49 CFR Parts 567, 571, 574, 575, and 597

[Docket No. NHTSA-04-17917]

#### Tire Safety Information

**ACTION:** Final rule; response to petitions for reconsideration.

Figure 1

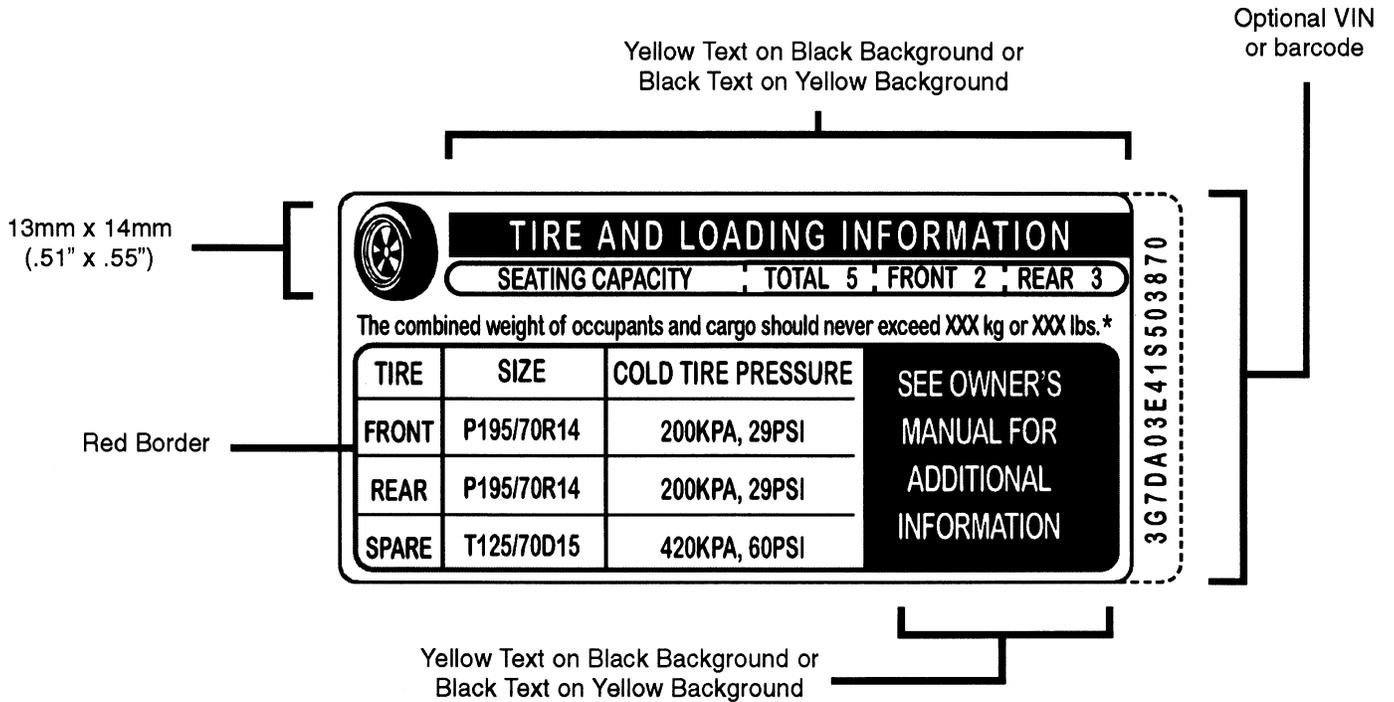
- The chart within the Vehicle Placard of Figure 1 is re-formatted to be identical to the chart within the Tire Inflation Pressure Label of Figure 2.

Vehicle Placard in Figure 1 so that the chart within the placard is formatted identically to the chart within the Tire Inflation Pressure Label in Figure 2. We conclude that the chart currently found within Figure 2 is better organized than the chart currently found within Figure 1. We believe that the uniform use of a single chart format will enable consumers to better understand the necessary tire information. Additionally, in those rare instances where a vehicle is equipped with front and rear tires of different sizes, the chart format from the Figure 2 will allow a manufacturer to identify different tire sizes for front and rear tires. The Vehicle Placard in Figure 1 has been revised accordingly. This rule contains updated examples of the Vehicle Placard and the Tire Inflation Pressure Label.<sup>15</sup>

\* For trailers, this statement should read:  
 The weight of cargo should not exceed XXX kg or XXX lbs.

Figure 2

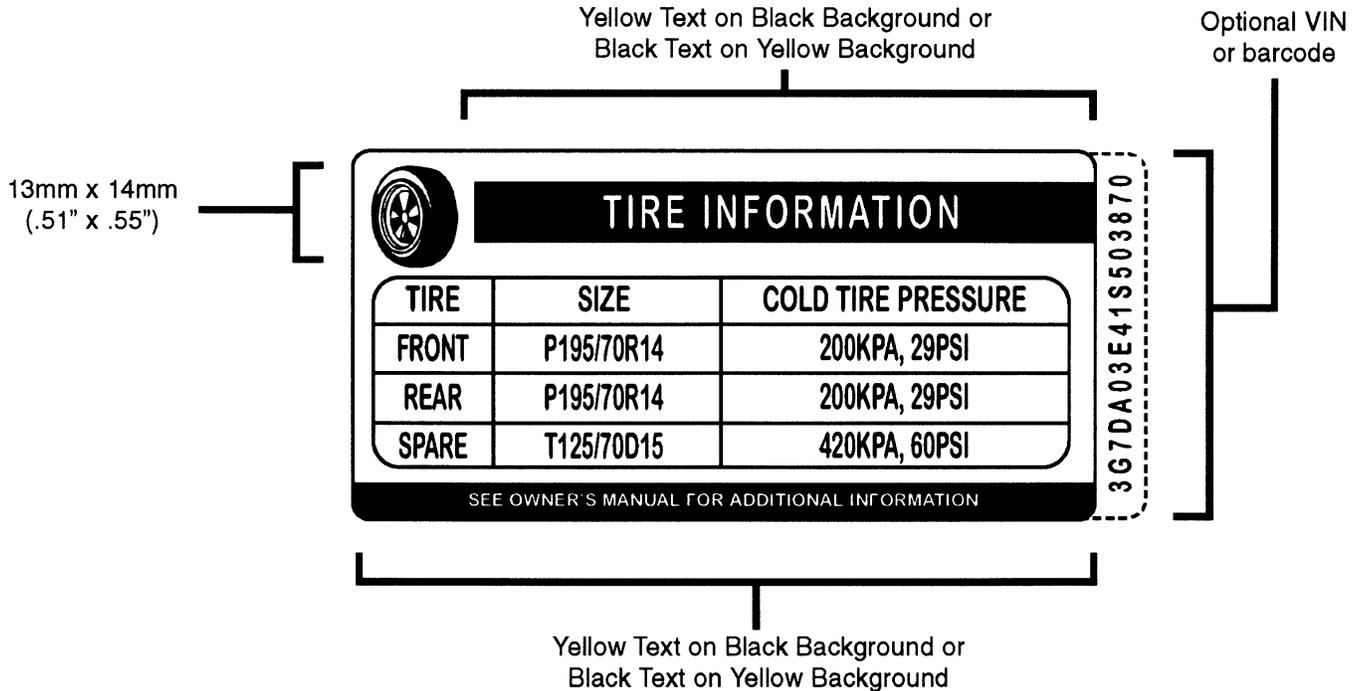
<sup>14</sup> We note that Figure 2 of the November 2002 final rule incorrectly contained the load index and the speed category symbol. This document contains corrected figures depicting the tire information label and the tire placard. The load index and the speed category symbol have been excluded from the revised figures.
